Re: Response to DPIE RFI - 2 April 2020 -on-land emplacement areas

This letter provides a response to a request for further information received via email on 2 April 2020 from the NSW Department of Planning, Industry and Environment's (DPIE) regarding the proposed on-land emplacement areas for Snowy 2.0 Main Works. The information requested was regarding:

Figure 3.1 Conceptual staging of water flows for construction phase excavated rock emplacement

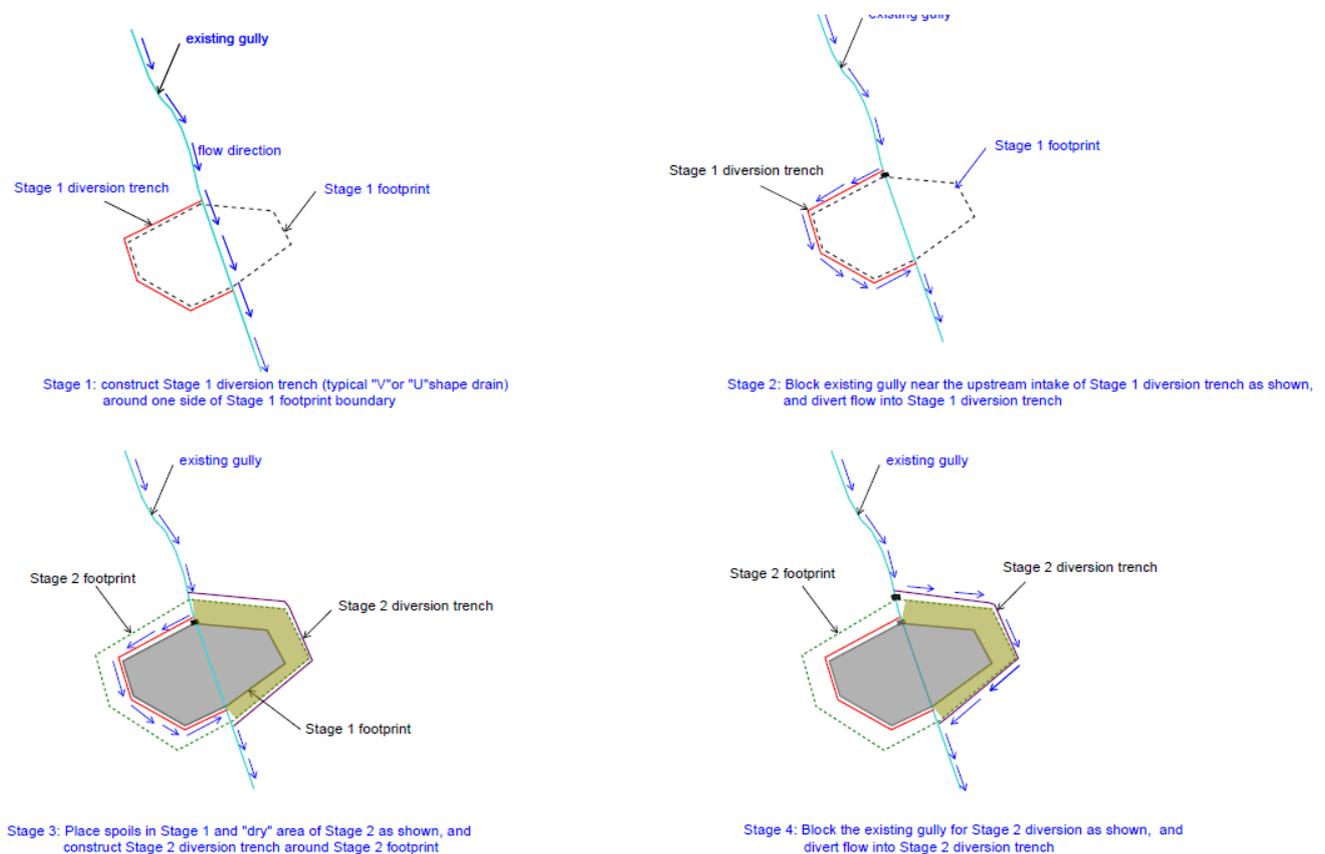
- ***For GF01, more information is required on:***

- ***the long-term velocities, tractive stresses and armouring required for the drainage lines post construction; and***
- ***the construction sequencing and management of water during construction.***

Alternatively, temporary water diversions will be constructed to divert natural flows from within the gully, around the perimeter of the stockpile area. The conceptual staging of water flow management during the construction phase of the emplacement area is provided in Figure 2.7 and described below.

- Stage 1: Prior to any placement of material, a diversion trench (typically an armoured V channel) will be constructed around the perimeter of the emplacement footprint.
- Stage 2: Once stage one is complete, the natural gully a temporary diversion structure will be constructed, diverting the flows into the newly constructed diversion trench.
- Stage 3: Placement of material can begin within the emplacement footprint, with flow being diverted through the temporary drainage channel around the perimeter of the footprint.
- Stage 4: Whilst placement is occurring and if required, a second diversion trench can be constructed to allow for expansion of the emplacement area, with a new diversion constructed to divert flows.

Figure 4.2 Tantangara GIP borehole location (BH1114)

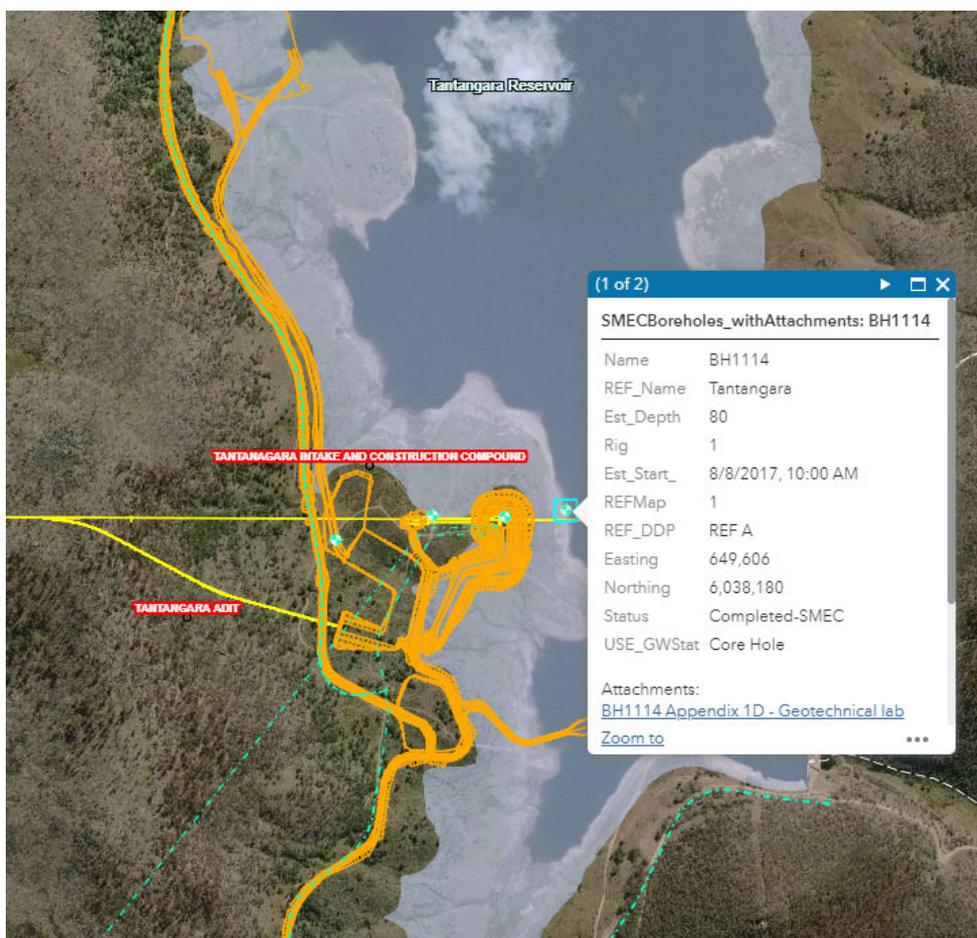
- ***For Talbingo, further information on the geotechnical investigations in the area (to the extent possible with the current levels of access) to confirm the long-term viability of the proposed diversion.***

An extract from the drill hole engineering log undertaken near the Tantangara intake location (BH1114) is provided in Figure 4.1. A map is also provided to show the location in Figure 4.2.
